To: Susan Grant, Acting City Manager
From: Alan Dodd, Director – Public Works
Date: June 3, 2024
Re: Change Order # 4 for Project #12765 PO 6189

Job Description: Project #12765, Prospect Lake Clean Water Center
Contractor: Prospect Lake Water, L.P.
Amount: Total amount of Change Order # 4 \$3,275,339 plus 0 additional days
Funding: 10-494-7999-536-60-6599-P12765

Subject: Prospect Lake Clean Water Center Design Build Contract
Response to Scope Change Order Proposal Request – City Obligations: 54 –Inch Feedstock
Watermain

PROJECT # 12765 FEEDSTOCK WATER MAIN TO PROSPECT WATER TREATMENT PLANT FORT LAUDERDALE, FLORIDA

CITY PROJECT # 12765
 FEEDSTOCK WATER MAIN TO PROSPECT
 WATER TREATMENT PLANT
 METER VAULT DETAILS

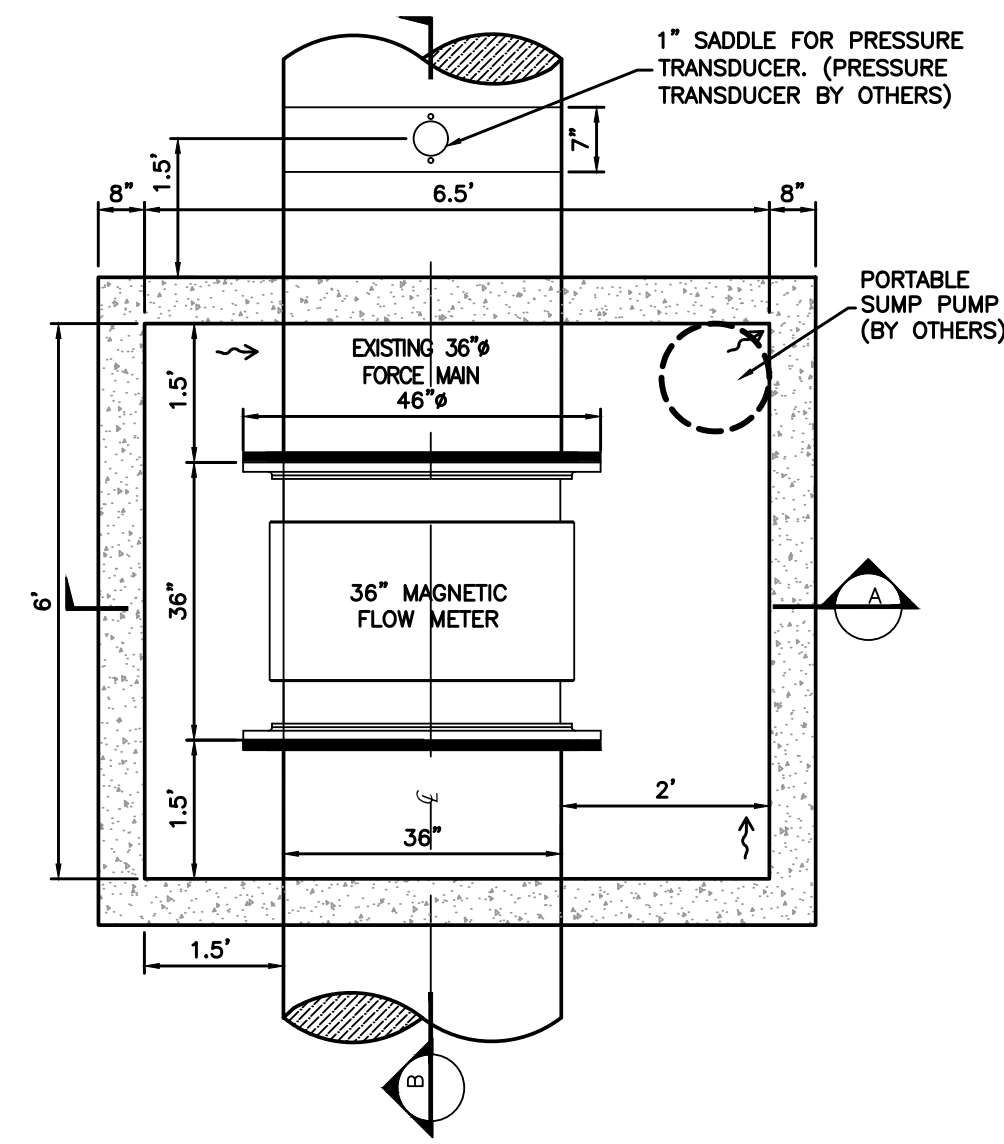
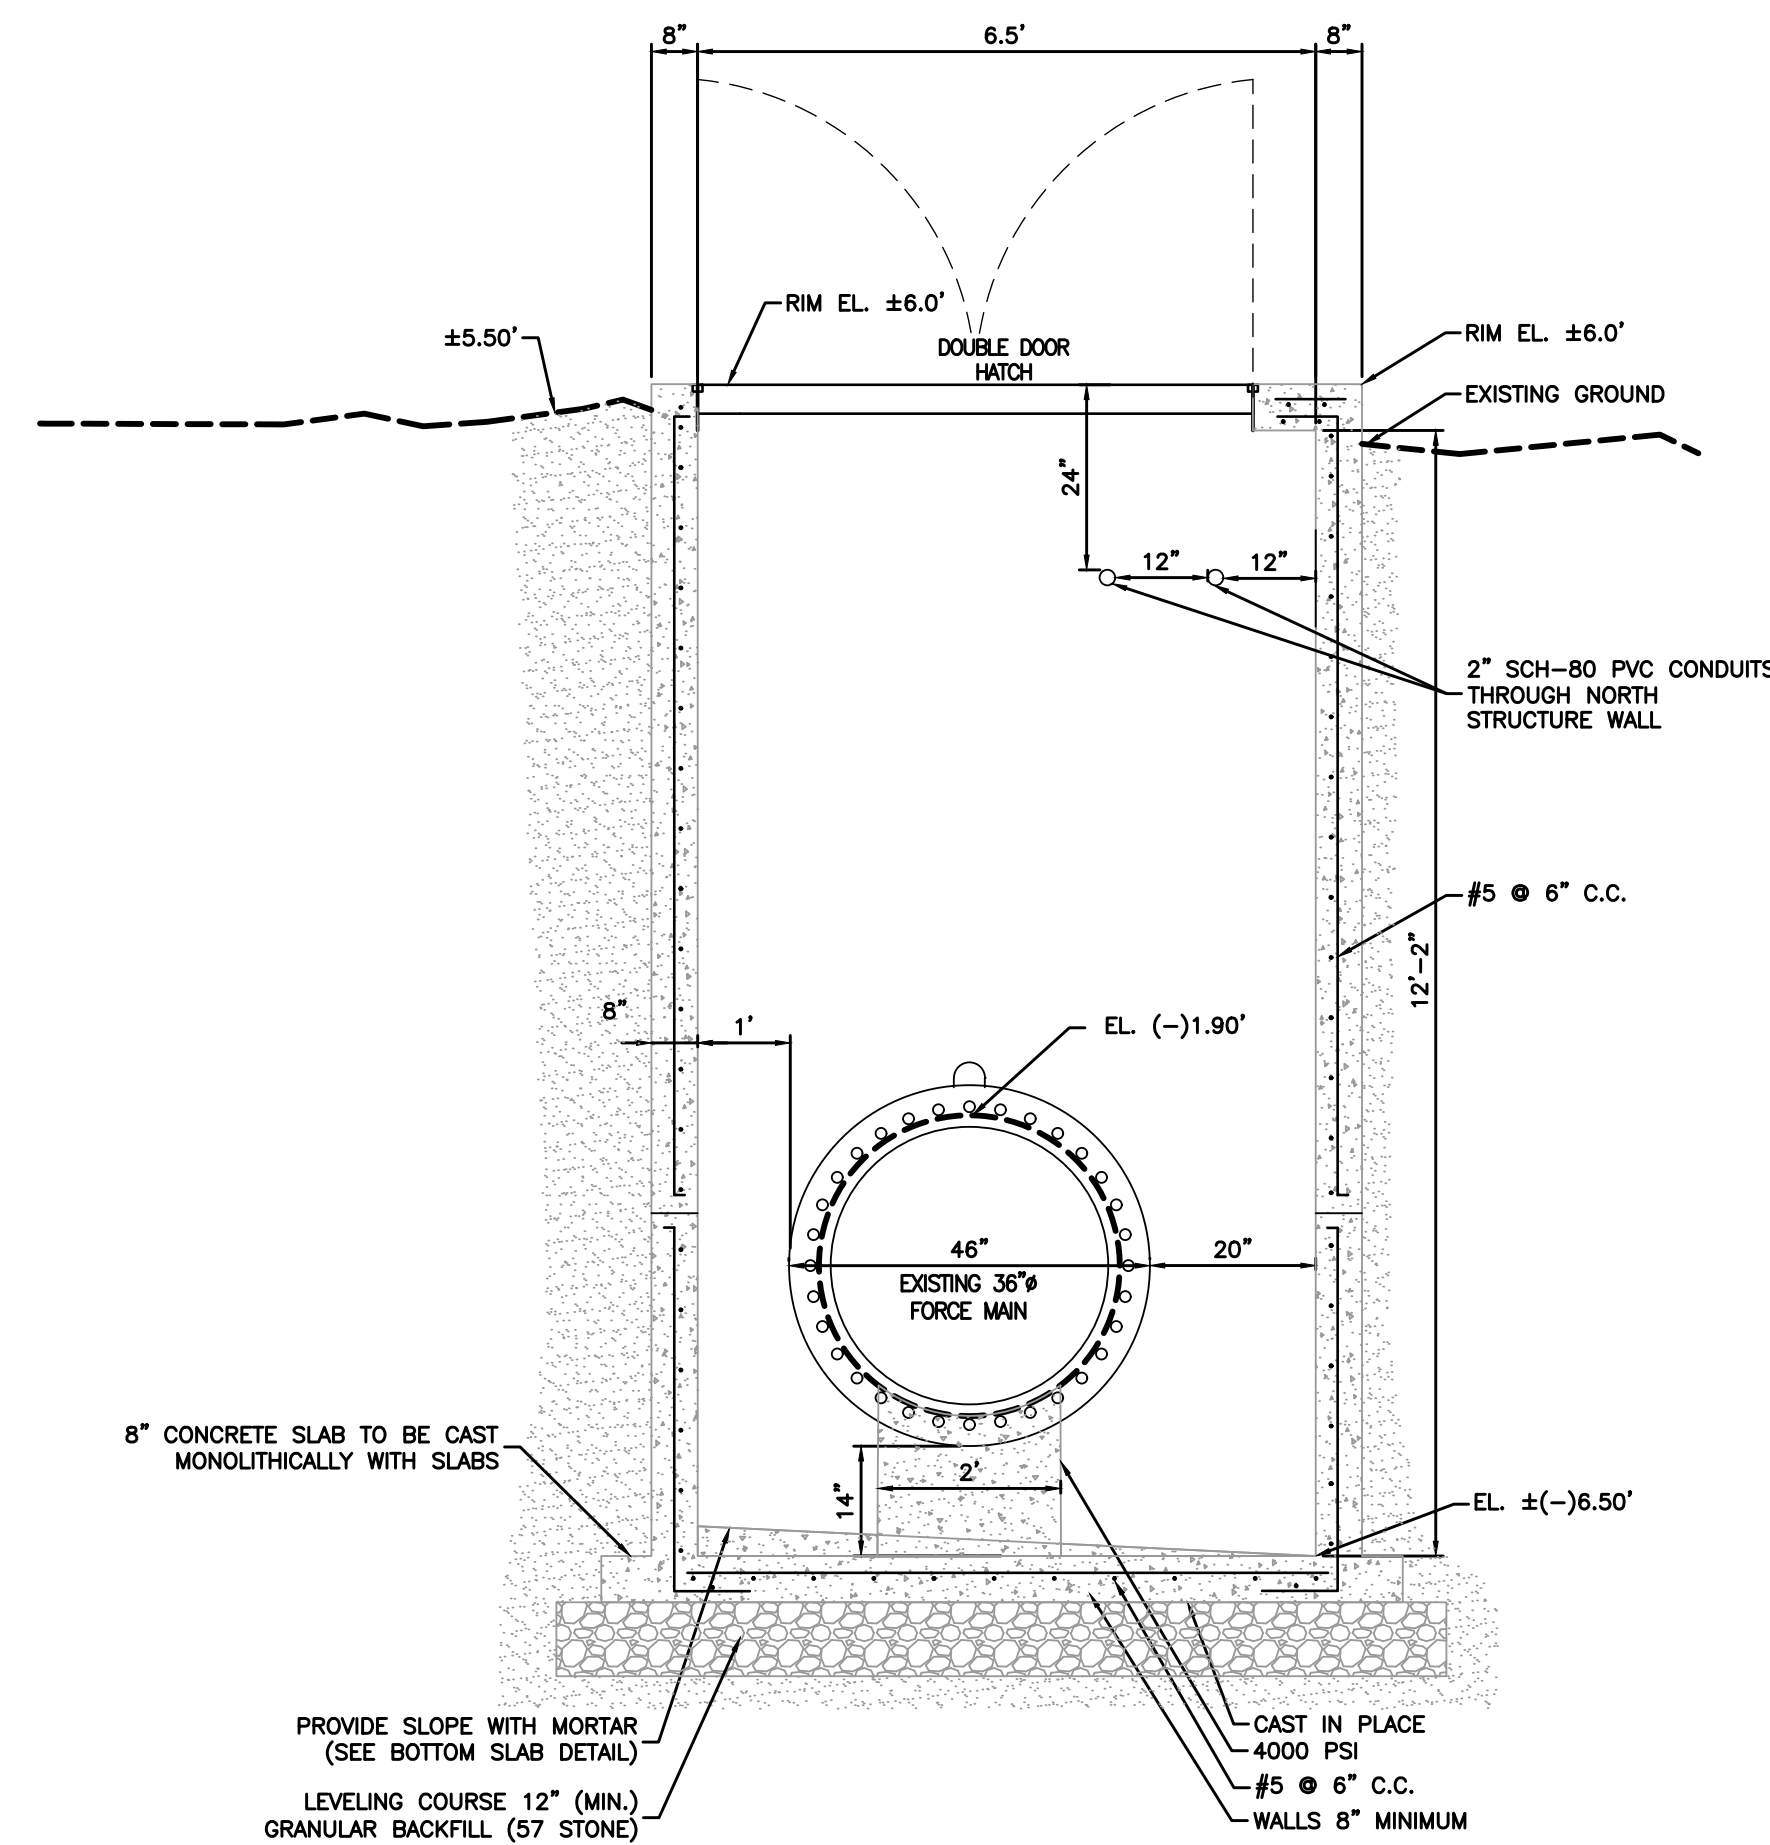
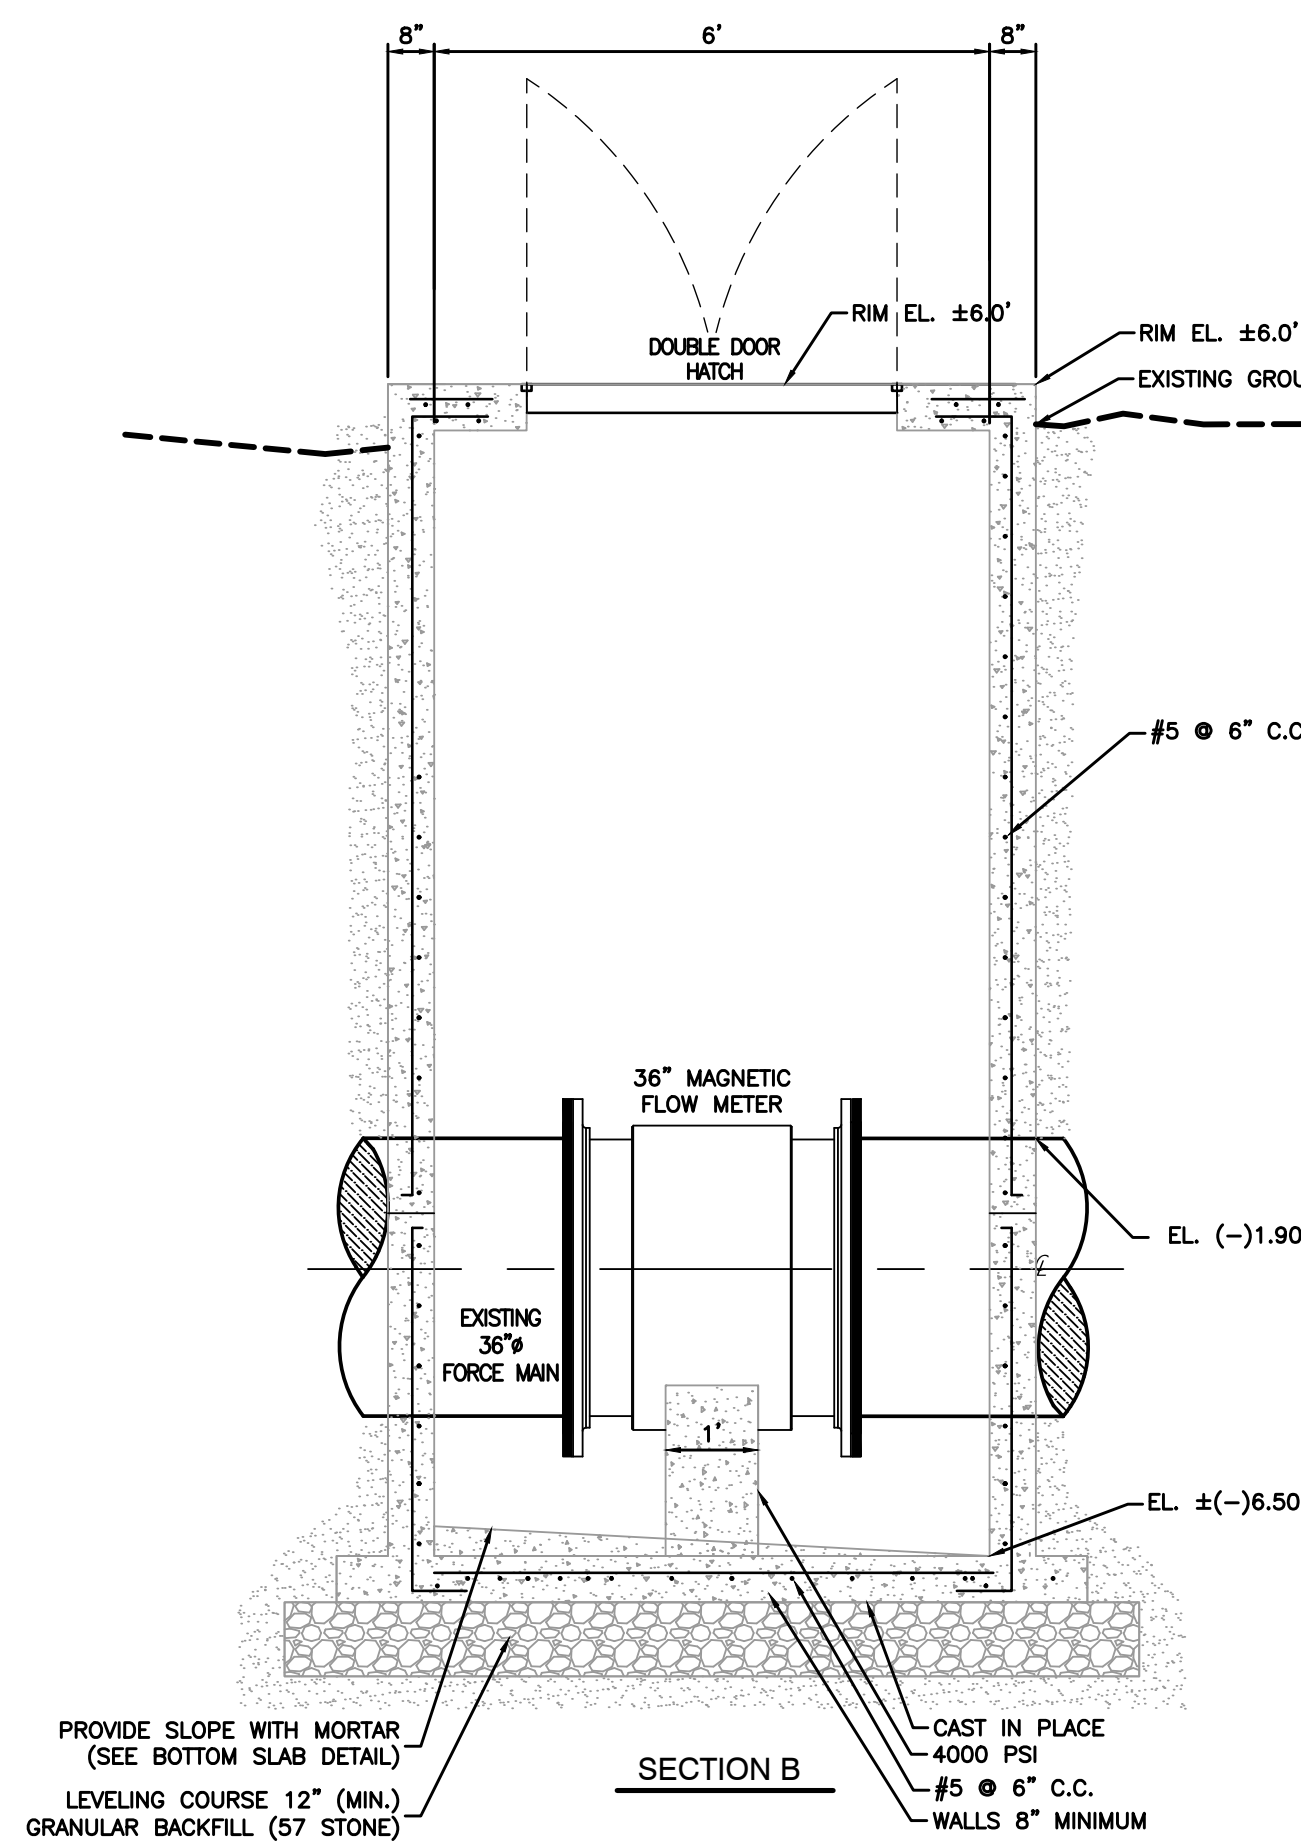
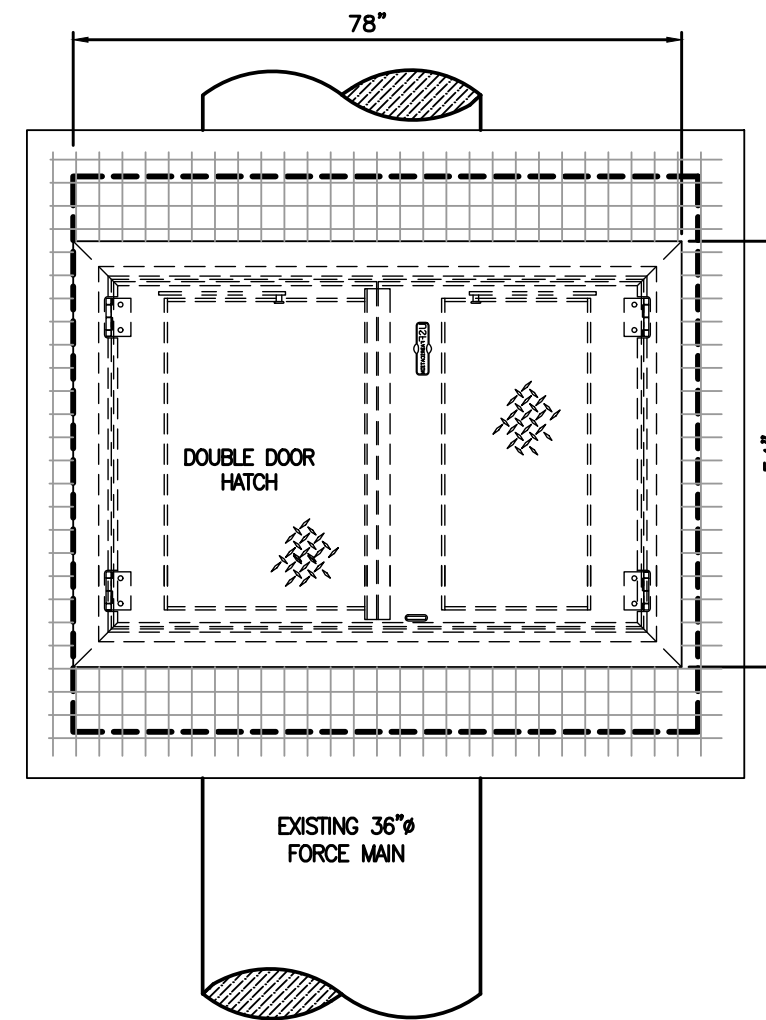
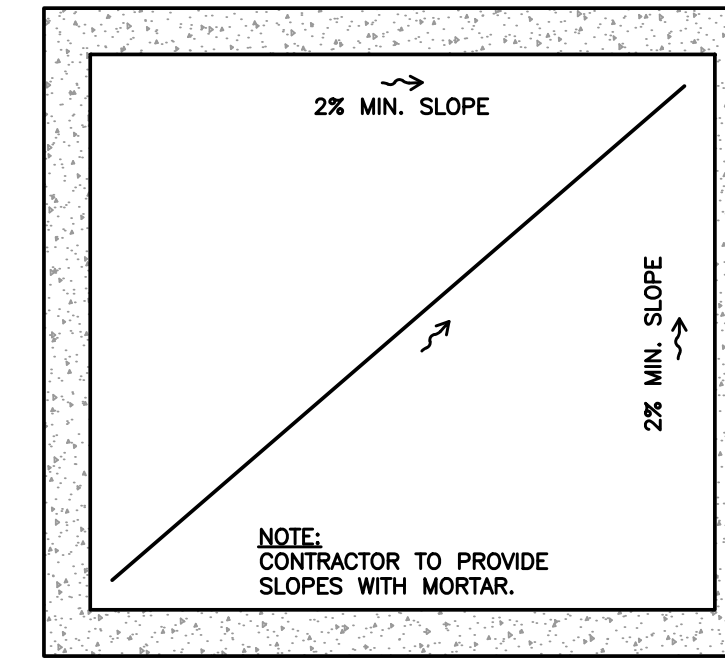
18. **Drawing D-3:** Drawing no. D-3 in the FWM Design Plan does not apply as there shall be no meter.
19. **Hazardous Materials:** General Note no. 44 in the FWM Design shall not apply. For the avoidance of doubt, Kiewit's rights and obligations with respect to hazardous materials will be as set out in the Comprehensive Agreement and the DB Contract.
